**Project: IEEE P802.15 Working Group for Wireless Personal Area Networks (WPANs)**

**Submission Title:** [Resolution for the initial SB comment No.3]

**Re:** [Response to the initial SB for the IEEE 802.15.7 standard]

# Resolution for the initial SB comment No.3

## 10. PHY I specification

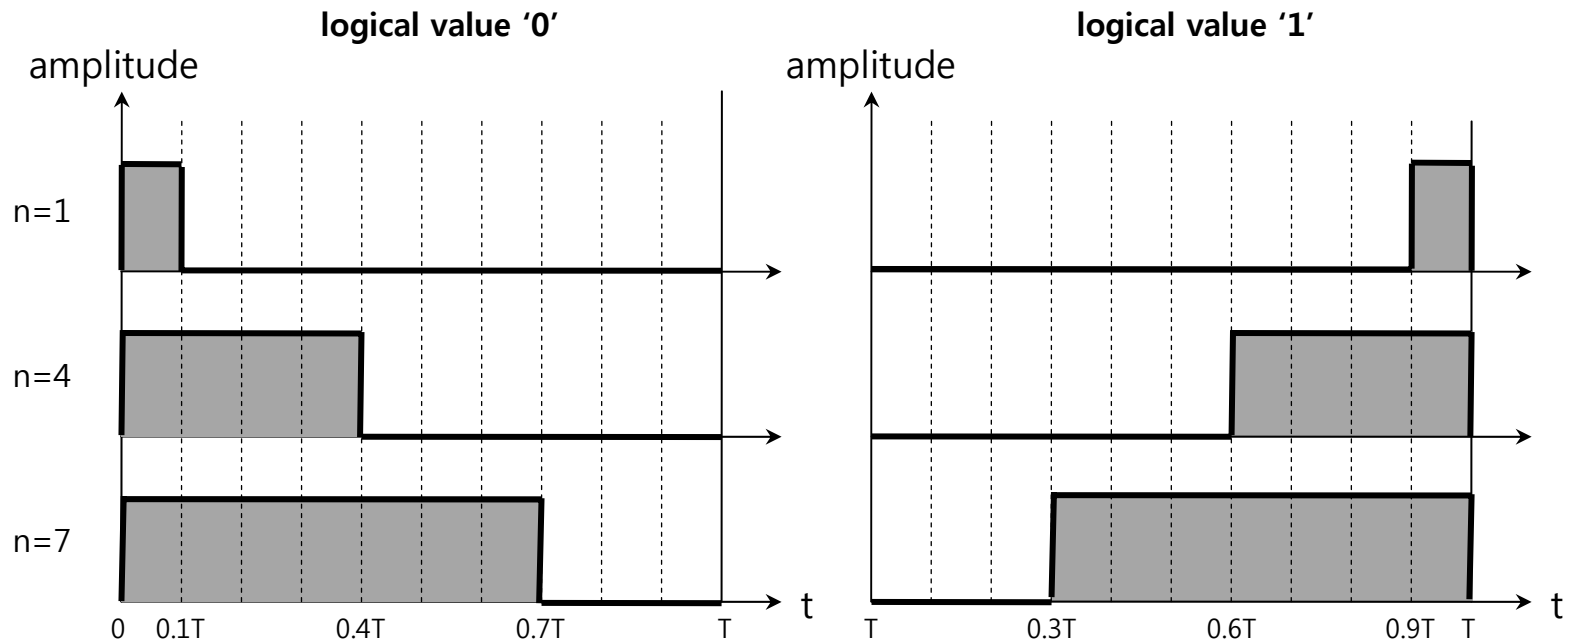
Comment No.	Name	Page	Subclause	Line	Comment	Proposed Change
3 (line 54)	Rajagopal, Sridhar	16	4.4.3.2.1	10	4.4.3.2.1 refers to 8.5.3 which refers to 4.4.3.2	fix circular reference

- 4.4.3.2.1 Intra-frame flicker mitigation
  - Intra-frame flicker mitigation is accomplished by either the use of run length limiting coding, modulation scheme, or both. Specifically, these schemes are manchester encoding as specified in 10.5.2, 4B6B encoding as specified in 10.5.1, 8B10B encoding as specified in 11.3 or **VPPM as specified in 8.5.3.**
- Main issue
  - 8.5.3 does not specify the VPPM definition, either.
  - **No place for the VPPM specification in D4.**

# Resolution details – Text for 10.6

- The data mapping for VPPM mode in **PHY I** is shown in Table xx and Figure xx. The data mapping for VPPM shall be defined as Table xx. The physical value mapped from the logical data “0” has a transition from ‘high’ to ‘low’ and the physical value mapped from the logical data “1” has a transition from ‘low’ to ‘high’ as shown in Table xx and Figure xx. ‘n’ in Table xx is the dimming level required only by VPPM and a integer **within the range of 1 to 9** so that VPPM modulated signals can support 10% dimming resolution only by VPPM. Figure xx shows the examples of the VPPM modulated waveform when the dimming levels, n, are 1, 4, and 7, respectively.
- Table caption : Table xx – Definition of data mapping for VPPM mode in **PHY I**
- Figure caption : Figure xx - Examples of the VPPM modulated waveforms in **PHY I** representing logical data ‘0’ and ‘1’
